APPEAL SUMMARY

Appeal ID: 27505	Project Address: 1510 NE 19th Ave, #2
Hearing Date: 2/16/22	Appellant Name: Sasha Beckwith
Case No.: B-004	Appellant Phone: 541-231-6318
Appeal Type: Building	Plans Examiner/Inspector: Robert Keal
Project Type: commercial	Stories: 2 Occupancy: R-2 Construction Type: V-B
Building/Business Name:	Fire Sprinklers: No
Appeal Involves: Alteration of an existing structure, occ Change from S to R2 none habitable storage	LUR or Permit Application No.: 21-098752-CO
Plan Submitted Option: pdf [File 1]	Proposed use: R-2

APPEAL INFORMATION SHEET

SHEET TITLE:
EXISTING: 3RD FLOOR

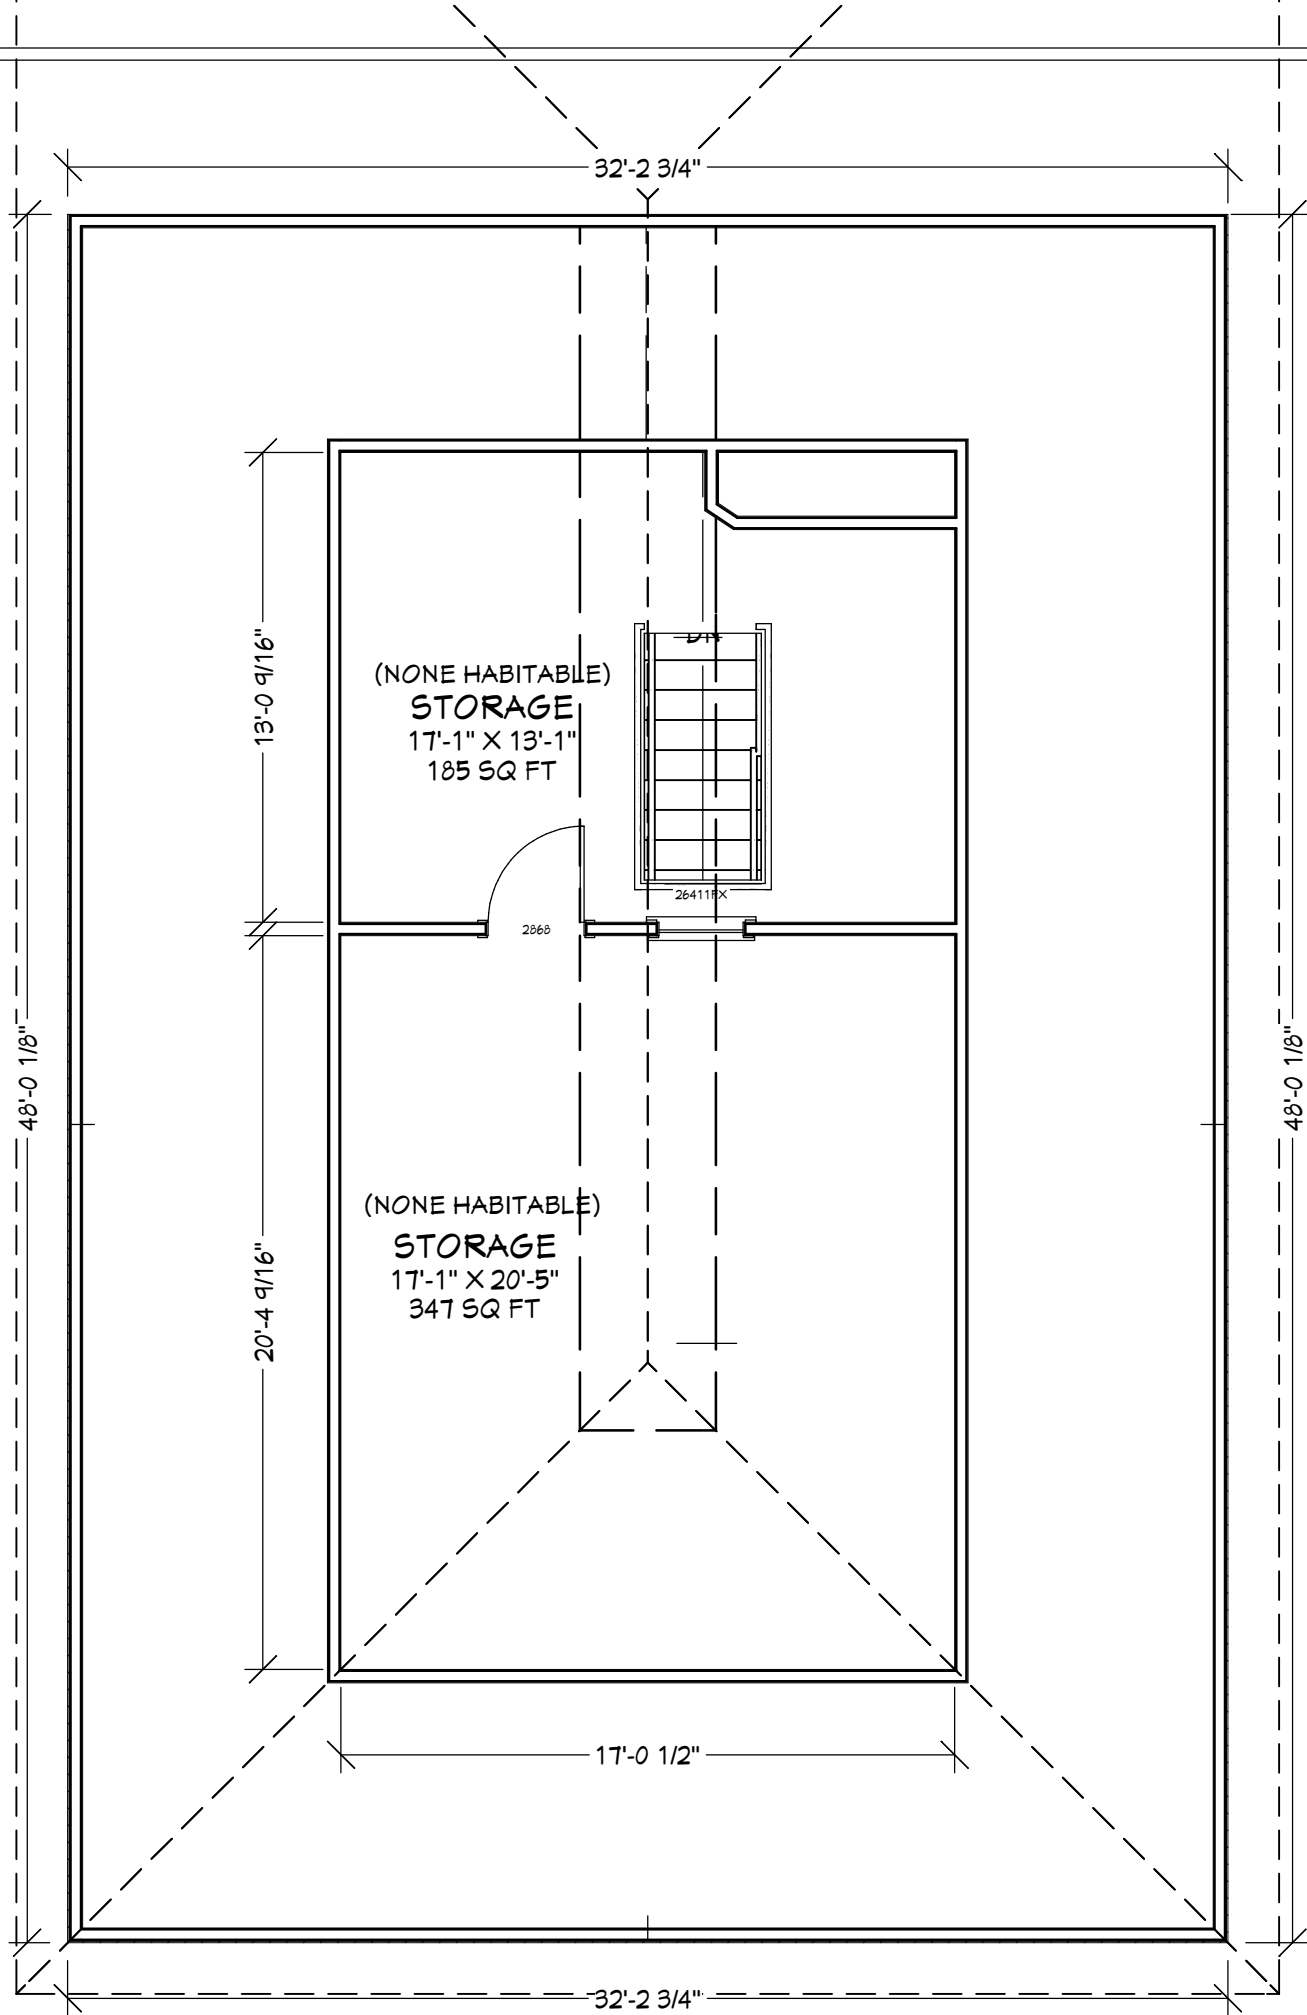
Code Modification or Alternate Requested	Still using this exception on the attic space only requiring sprinklers instead of the entire unit
Proposed Design	We proposed to install an NFPA 13 R standard sprinkler system only in the attic storage space but not needing to install it throughout the entire building/condo.
Reason for alternative	Due to the age of the home it would be very costly to put a system in the entire condos. Since this space is none habitable but only storage space that is accessed by stairs, we ask the exception to only be installed in this area be extended due to it being a none habitable attic space which will have less traffic in general but still be protected with a sprinkler system.

ONLY WORK DONE ON THIS FLOOR IS INSTALLING
AN AUTOMATIC SPRINKLER SYSTEM MEETING
NFPA 13 R STANDARDS (FOR THIS LEVEL ONLY)

Installation of Type 13D sprinklers in attic space only: Denied. Proposal does not provide equivalent Life Safety protection.
